HOOPER CITY COUNCIL MEETING
5580 W. 4600 S. Hooper, UT 84315
Thursday, November 05, 2020
7:00 PM

**HOOPER CITY STAFF
SUBDIVISION PLAN REVIEW**

**MORNING MEADOWS
SUBDIVISION**

To: Hooper City Community Development Coordinator
From: Public Works and Engineering
CC: Brad Beus, Mayor Fowers, Jared Hancock
Date: September 22, 2020
Re: Morning Meadows Subdivision - J-U-B Project No. 5518007-020

Cover/Index Sheet

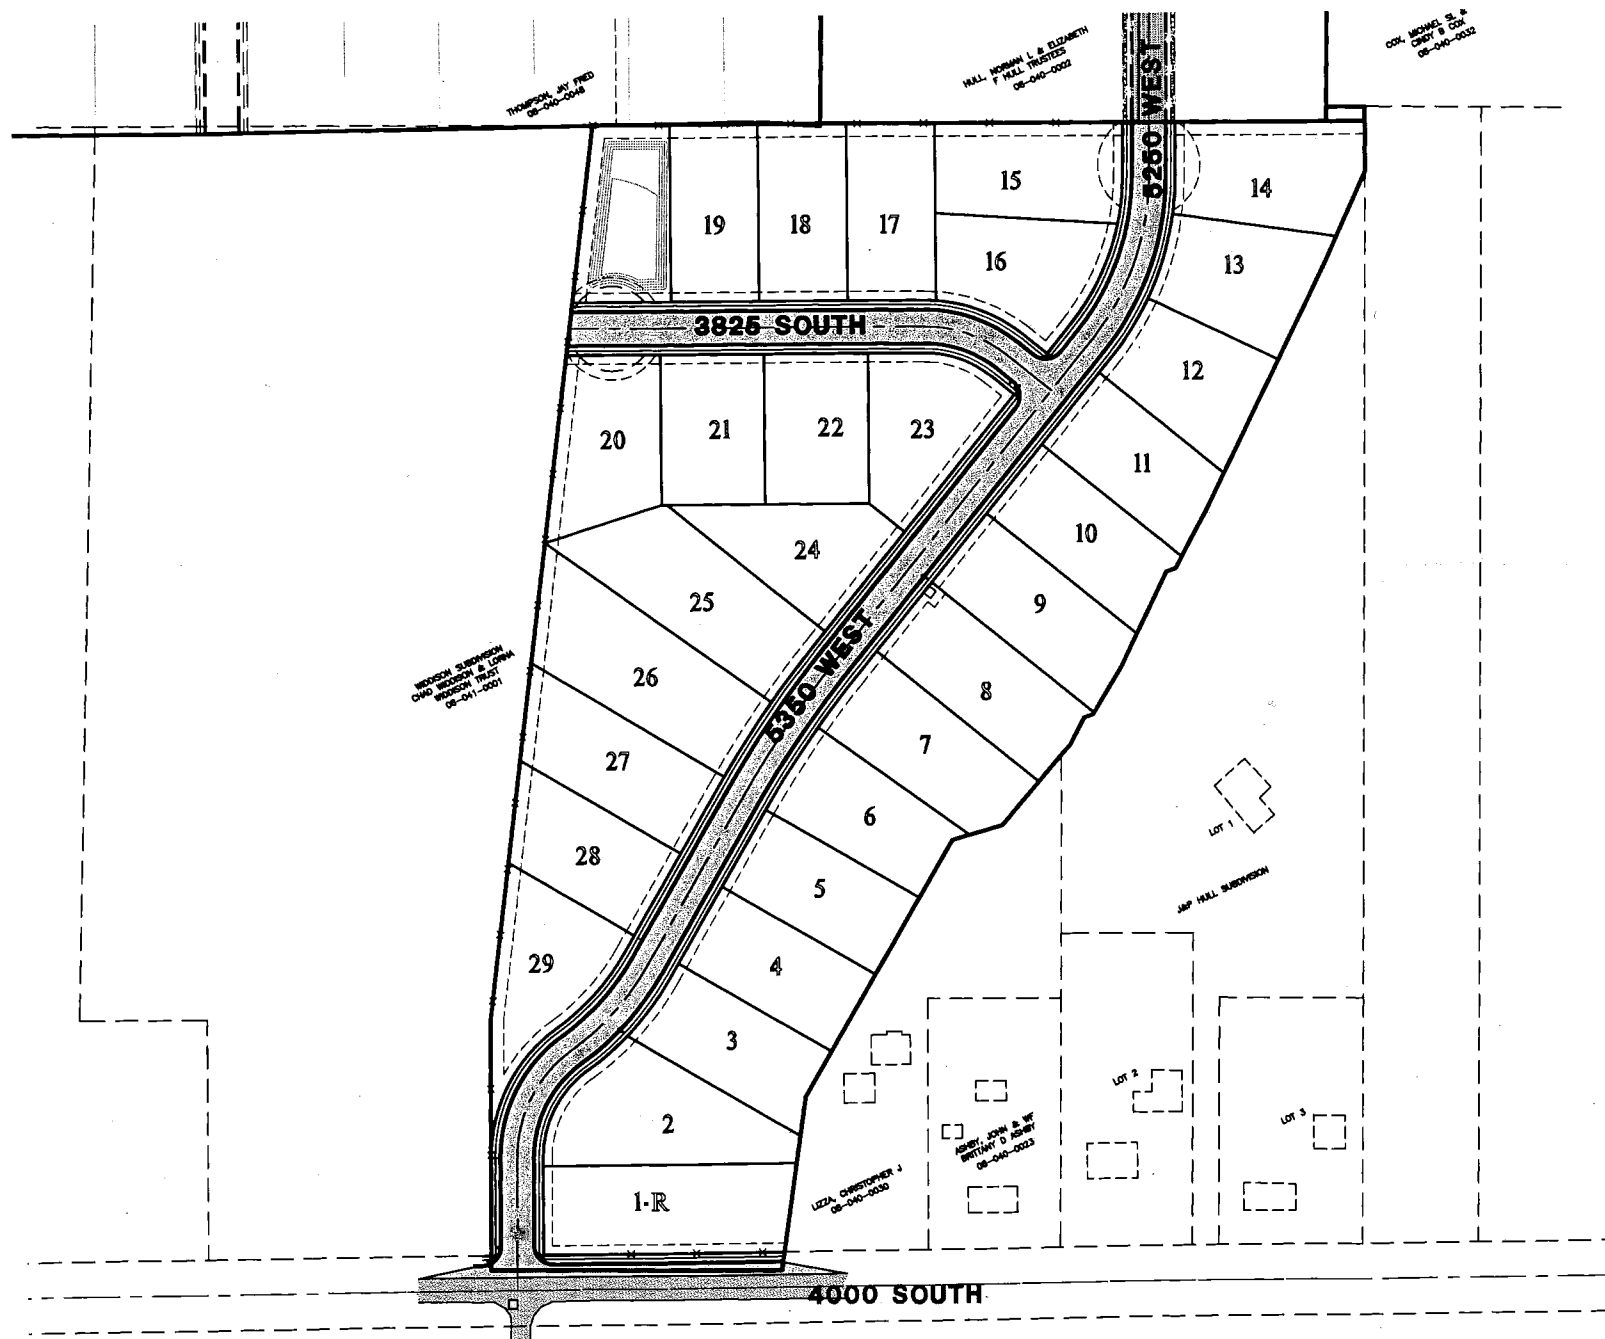
Public Works and Engineering have completed the fourth Final Plat review of the Morning Meadows Subdivision which will create 29 lots on 18.3 acres in the City's R2 zone. This review is based upon a revised improvement plans identified as Revision 10 which were delivered to the City office on September 14, 2020. The subdivision is located at approximately 4000 South and 5350 West. Comments from the previous reviews are shown below. Comments from this third review are shown in **green text**.

1. The slope of the vacuum sewer main must be shown in the profile view. The slope of the vacuum sewer main has now been shown in profile. However, it is still not clear to Public Works or the future contractor who will build this pipeline exactly what the final design will look like because the point of connection in 4000 South is shown as “field verify.” The vacuum sewer hydraulics regarding number of lifts and slope are too critical to be left to the contractor to determine. If the elevation of the connection point can’t be verified through potholing ahead of time, be aware that the construction of the vacuum main will be delayed until a new plan can be reviewed after the connection elevation is determined. **The slope of the vacuum sewer has been noted on the plans. The developer has indicated that he is planning to identify the location of the existing vacuum sewer in the field by potholing in the highway at a later date to field verify. We are still strongly recommending potholing in order to prevent delays in the construction of the project. OK**

1. The vacuum sewer is too shallow at the north end of this profile view. The slope has not been shown, but it is clear that it can be laid flatter (minimum slope of 0.2%). Please refer to Note 1 of Sheet 5. **OK**
2. The secondary water service and the storm drain comb box between Lots 28 and 29 are too close together to provide for proper future maintenance. A similar condition exists on the opposite side of the road. Please revise. **OK**
3. A street light will be required along 5350 West (600-foot maximum spacing). The preferred location is in the vicinity of the buffer tank shown on Sheet 5. **OK**
4. **New Comment: The secondary waterline will not be permitted under the curb and gutter as currently shown on this sheet. OK**

1. The vacuum sewer is shown incorrectly in the profile view on this sheet. It is shown connected to a manhole. It is shown correctly in the plan view except that there are no 90-degree bends in the vacuum sewer. Two 45-degree bends are required. **OK**
2. Regarding the vacuum sewer profile, the maximum lift in the buffer tank is 8 feet, but less lift is preferred. The vacuum main itself typically has 4 to 5 feet of cover. It can be laid at a slope as low as 0.2%. Please consider this design criteria and adjust the vacuum sewer profile accordingly. **A profile view between SSMH#6 and the buffer tank is required in order to ensure that the buffer tank is installed correctly. Please clarify. This view has been provided. OK**

1. Hooper City does not want to receive runoff from UDOT's highway into its storm drain and detention basins. A plan to handle the highway drainage as it has historically been handled is required. **The plan has been updated. However, the plan shows the west end of the storm drain emptying into an irrigation ditch. The drain ditch is on the south side of 4000 South. Please clarify. Regarding the storm drain itself, the City will rely on UDOT for approval of the drainage plan in the state highway. The developer is planning to empty the storm drain into the existing ditch on the north side of the highway. This is acceptable to the City as long as UDOT has no objections. OK**

1. We are unable to correlate the storm drain outfall line and the elevations shown for EXSDMH and the elevations shown for the corresponding storm drain manhole in the Silver Saddle Subdivision. Please clarify. **The response to this comment from the developer is to "see Sheet 11 on Silver Saddle Subdivision." Sheet 11 in the set of plans that the City has is part of the SWPPP. Sheets 7 and 9 show the storm drain piping through an easement in Lot 19 of Silver Saddle. We are still unable to correlate this with what is shown in Morning Meadows. It will be necessary to show a portion of Silver Saddle Subdivision in these plans so that the storm drain correlation between the two developments can clearly be seen. A new drawing was provided to show the relationship between the storm drain outfall from Morning Meadows and Silver Saddle Subdivisions. There is still a problem between the two sets of plans. The storm drain manhole at the property boundary on the Silver Saddle plans show a rim elevation of 4235.00 and an invert elevation of 4229.74. These elevations do not match the elevations shown on Sheet 10.1. Please clarify. This has been corrected. OK**

5. New Comment: IRRBOX#1 and IRRBOX#2 are actually drain boxes and should be labelled accordingly. OK
6. The box labelled "New Irrigation Box per Quail Cove" is shown on Sheet 19 with a note to "connect to existing" piping. The box needs to be replaced along with the piping around it. Please clarify. OK

Public Works and Engineering recommend this subdivision for Final Plat approval.
